**Subject: Beaver Valley Power Station, Unit No. 1
Docket No. 50-334, License No. DPR-66
Response to Request for Additional Information in Support of
License Amendment Request No. 328, Revised Steam Generator
Inspection Scope for One Cycle of Operation**

**REQUEST FOR ADDITIONAL INFORMATION
BEAVER VALLEY POWER STATION UNIT 1 (BVPS-1)
ONE-CYCLE APPROVAL TO USE W* METHODOLOGY
FOR STEAM GENERATOR (SG) TUBE INSPECTION
DOCKET NO. 50-334**

FirstEnergy Nuclear Operating Company
Beaver Valley Unit 1
Revised Steam Generator W* Figure

Figure 1

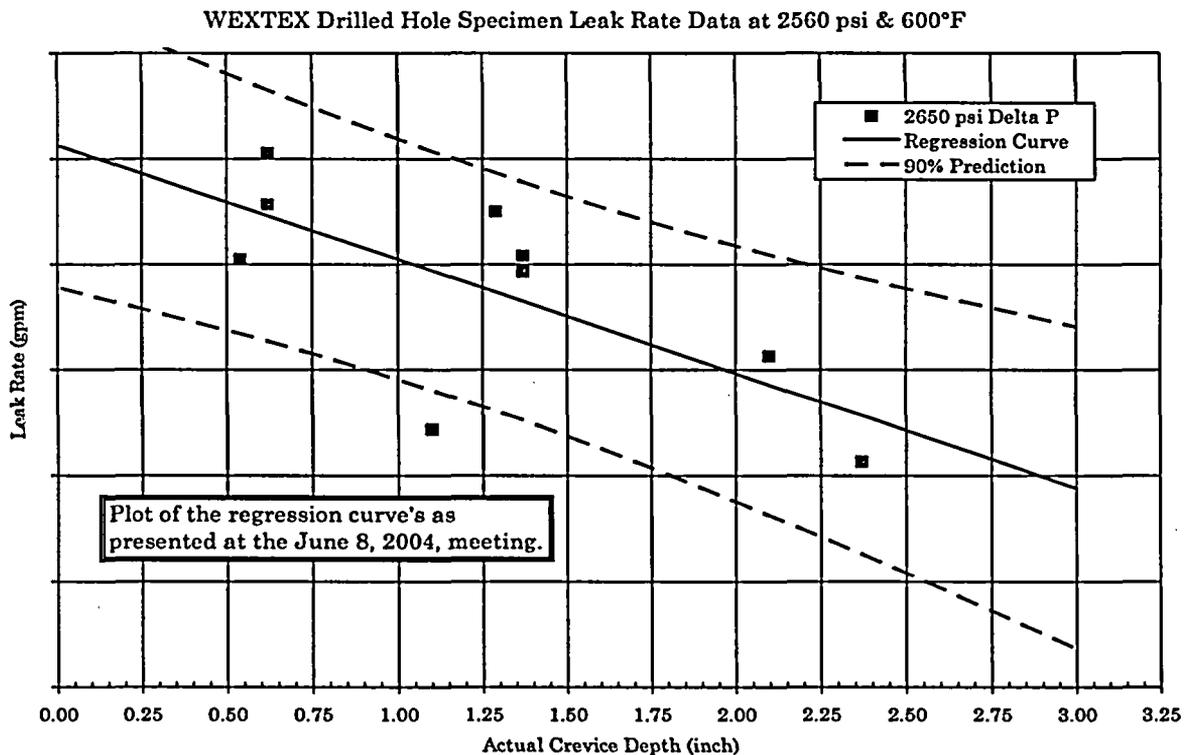
Slide 19 of the June 8, 2004 presentation (ADAMS No. ML042010038) presented a linear 1st order regression curve of the common logarithm of the leak rate as a function of the actual crevice depth. The regression analysis included only the data obtained at an intended differential pressure of 2650 psi; however, the last bullet of slide 18 noted that the regression lines for intended differential pressures of 1620, 2000, and 2650 were not statistically different, thus, all of the data could have been included in the regression analysis. Moreover, the actual contact pressure for each specimen was calculated. Thus, a model of the leak rate as a function of crevice length could be expanded to include the contact pressure as,

whereas the contact pressure was not included in the regression results presented at the June 8 meeting. It was noted during the meeting that a significant reduction in the predicted leak rate would be realized if the pressure term were added. The figure from the meeting presentation is included herein as Figure 1. The results from the preliminary analysis of the grouped data are presented in Figure 2. A significant reduction of the predicted leak rate is readily apparent relative to the Figure 1 regression results.

Figure 2

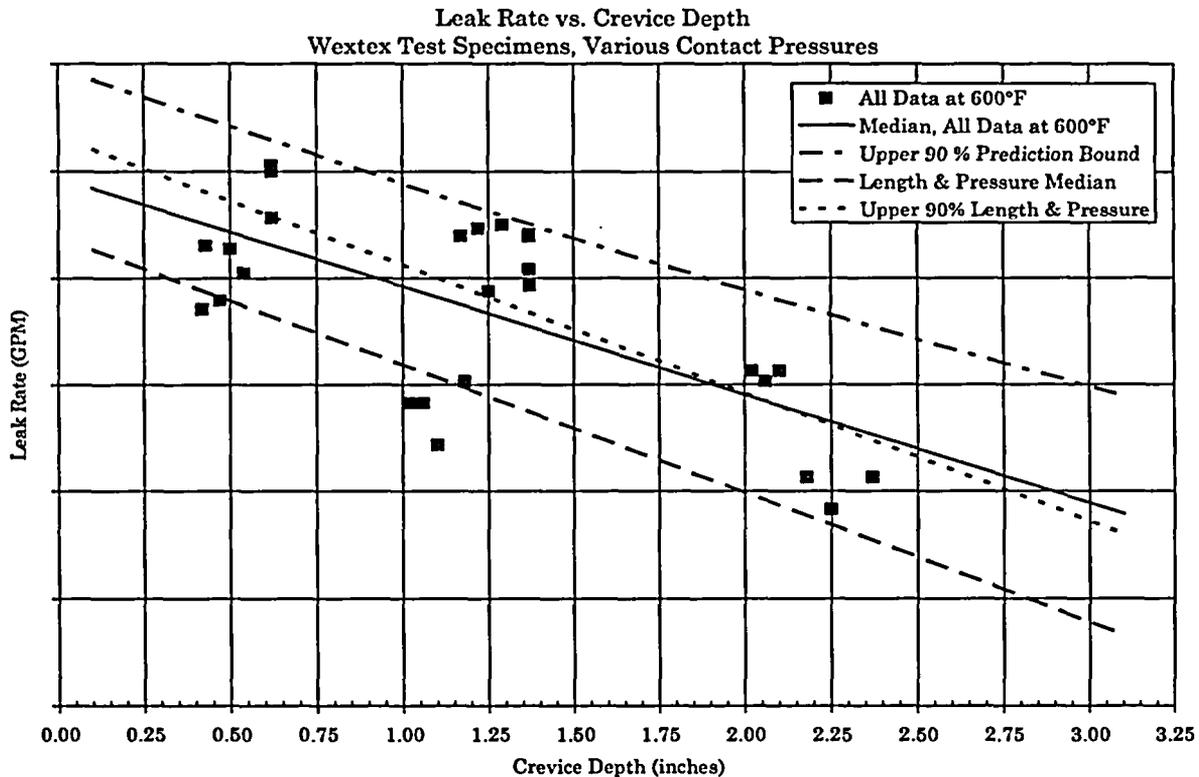
3. Figure 4.3.5 in the submittal depicts the leakage from the drilled hole specimen tests as a function of actual crevice depth. Figure 4.3.7 depicts the calculated contact pressure for the most limiting Zone A and B tubes as a function of distance below the TTS under faulted conditions. In addition, Figure 4.3.7 provides the average contact pressures for the 1.25-inch, 2-inch, and 3-inch drilled hole leak test specimens. Figure 4.3.7 relates the contact pressures for the leak test specimens to the most limiting Zone A and B tubes. Discuss the rationale for not developing a direct correlation between the drilled hole specimen leak rates and their associated contact pressures and then determining the leak rate for a Zone B tube based on the contact pressure at 8 inches and 12 inches.

During the discussion with representatives of the NRC staff on August 26, 2004, it was noted that the contact pressures used for the presented correlation did not include any reduction for the fluid pressure in the crevice. Moreover, the contact pressures noted for the SG do include a reduction of the contact pressure to account for a postulated 800 psi fluid pressure in the crevice. This means that for a given leak rate, a higher contact pressure is deemed to be needed using the analysis results. Conversely, for a given calculated contact pressure the associated predicted leak rate will be higher than indicated by the test data. In summary, the exclusion of the crevice pressure for the test data and the inclusion of the crevice pressure for leak rate prediction purposes is conservative.

As the specimen contact pressure did not include allowance for the WEXTEx residual contact pressure contribution, the individual y-axis points of Figure 4.3.7 of the LAR should be reduced by 693 psi. This would then be consistent with the data of Table 4.3-9 with regard to contact pressure as a function of depth below the TTS. As stated in the response to Question 3, the average contact pressures for the specimens at the corresponding elevations of equal contact pressure in the tube are conservative for the elevation assumption applied in the LAR with regard to leak rate applied to the 8.00" to 12.00" below the TTS and greater than 12.00" below the TTS depths. A revised Figure 4.3.7 is provided in Attachment B (Attachment C provides the non-proprietary Figure 4.3.7). The contact pressures in this revised plot are taken from Table 4.3-9 of WCAP-14797.
